STATE OF DELAWARE  
**DEPARTMENT OF TRANSPORTATION**  
800 BAY ROAD  
P.O. BOX 778  
DOVER, DELAWARE 19903

RE: Agreement No. 1946F  
Traffic Impact Study Services  
**Task No. 5A Subtask 04A – Levels View Farm**

McCormick Taylor has completed its review of the Traffic Impact Study (TIS) for the Levels View Farm development prepared by Bowman Consulting Group, Ltd., dated January 10, 2024. Bowman prepared the report in a manner generally consistent with DelDOT's Development Coordination Manual.

**Scope of Improvements Figure**  
**Levels View Farm TIS**

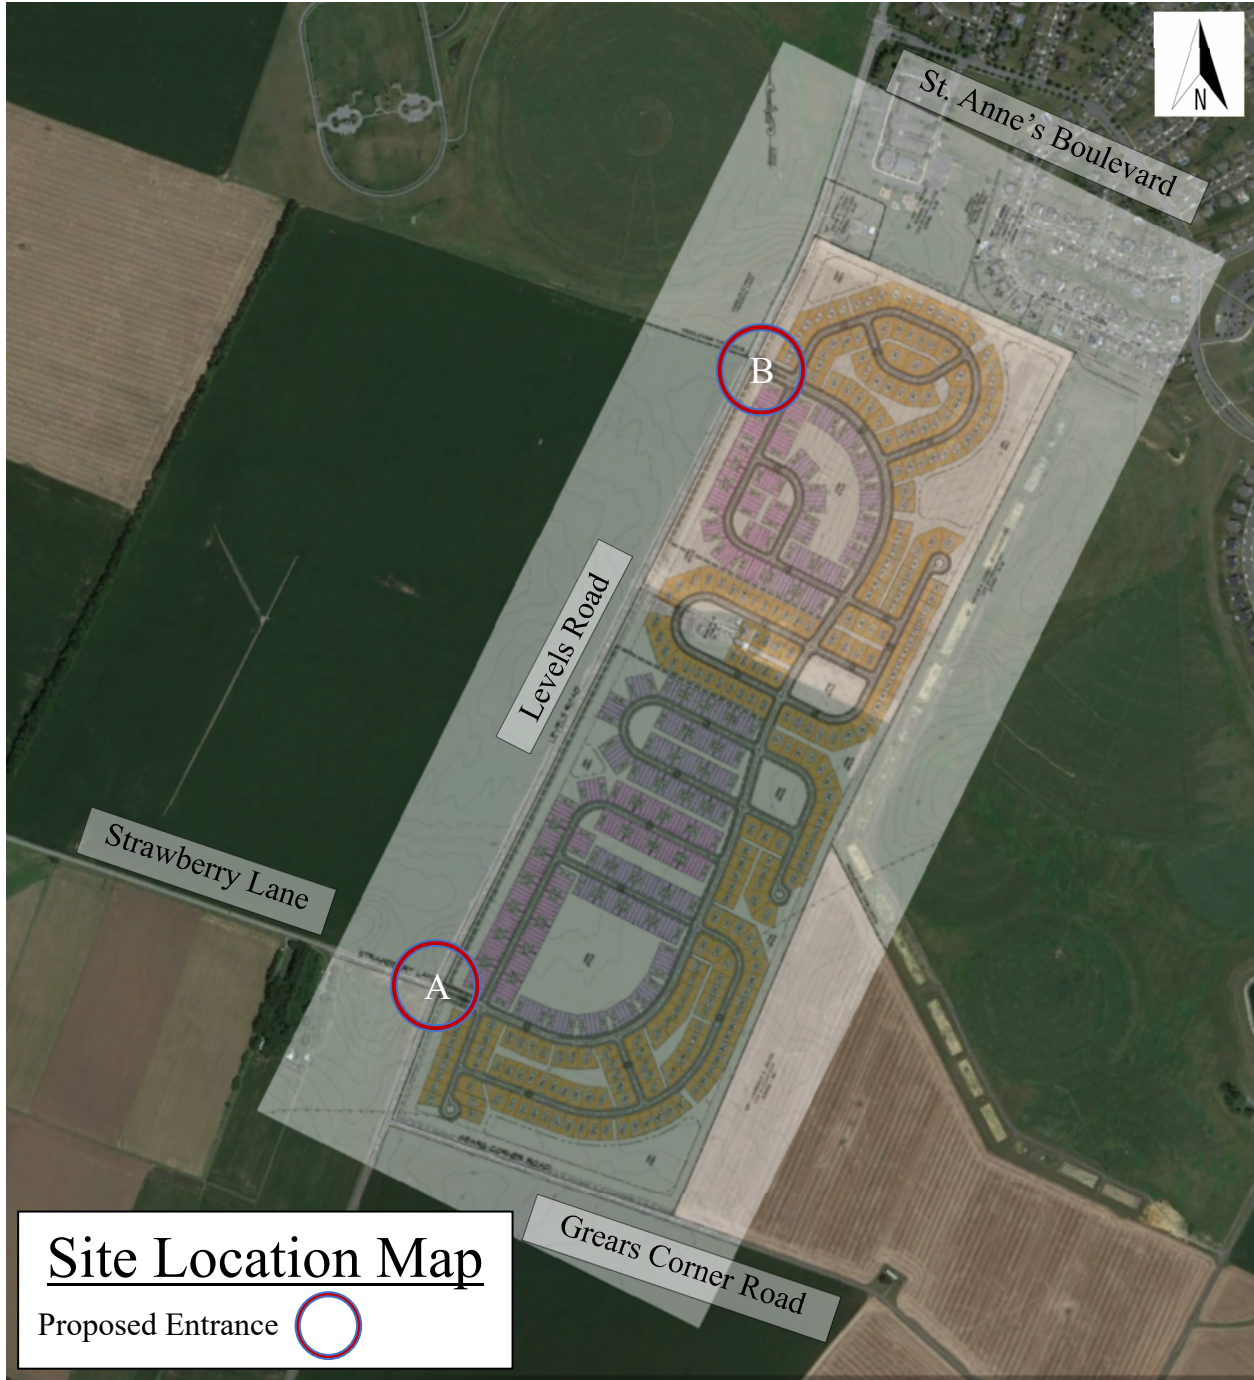
-  Proposed Site Entrance - Frontage improvements and turn lanes as described in the review letter.
-  Study Intersection - Recommended Improvements
-  Study Intersection - No Improvements
